# TECH ADVISORY

## TORQUE CONVERTER

### Standard Length Studs (.650") for All Ford Billet Front Covers

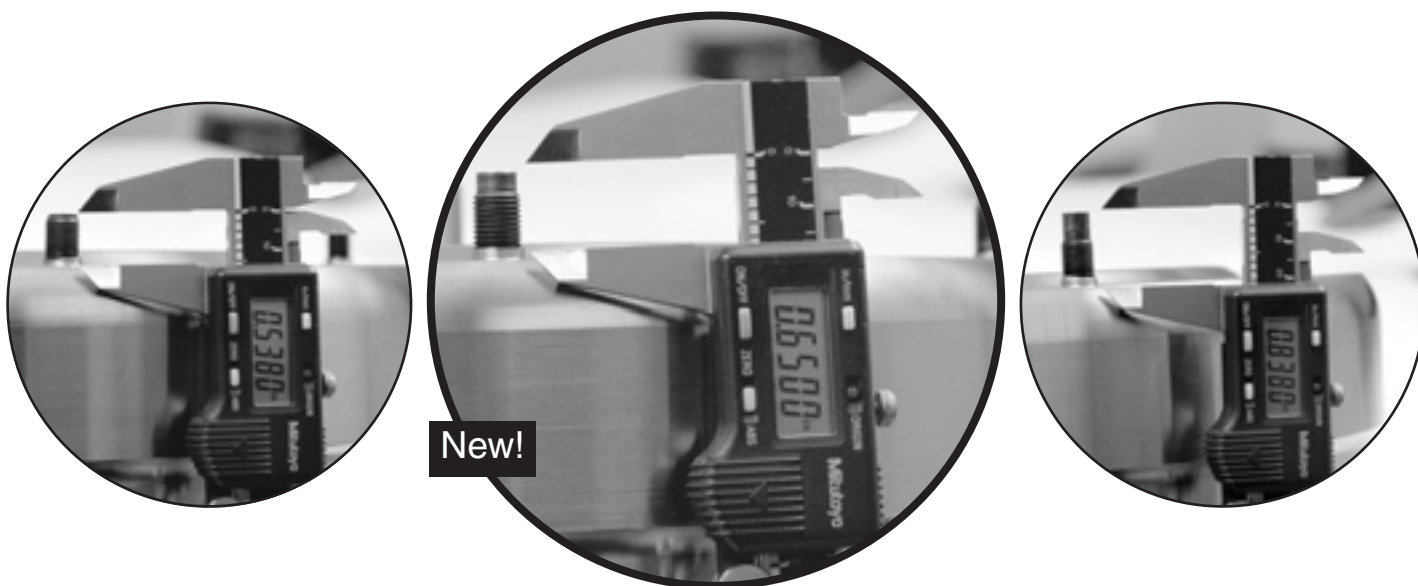
Sonnax will be standardizing the stud length on all Ford billet front covers. Some part numbers will be changed slightly as referenced below. Pictured below are details showing the earlier short stud (.538"), long stud (.838") and the new, universal length stud (.650"). These universal stud length covers can be used in both gas and diesel applications.

PART NUMBER	DESCRIPTION
<b>FD-CC-11</b>	E4OD 6-Stud (Replaces <b>FD-CC-11S</b> )
<b>FD-CC-12</b>	E4OD 4-Stud (Replaces <b>FD-CC-12D</b> and <b>FD-CC-12G</b> )
<b>FD-CC-17S</b>	E4OD, 4R100 Grob, 6-Stud
<b>FD-CC-17L4</b>	E4OD, 4R100 Grob, 4-Stud
<b>FD-CC-19R</b>	AODE, 4R70W, 12", Reaction Surface Finish, 4-Stud
<b>FD-CC-20R</b>	AODE, 4R70W, 11-1/4", Reaction Surface Finish, 4-Stud
<b>FD-CC-21S</b>	5R110W, Grob, 6-Stud
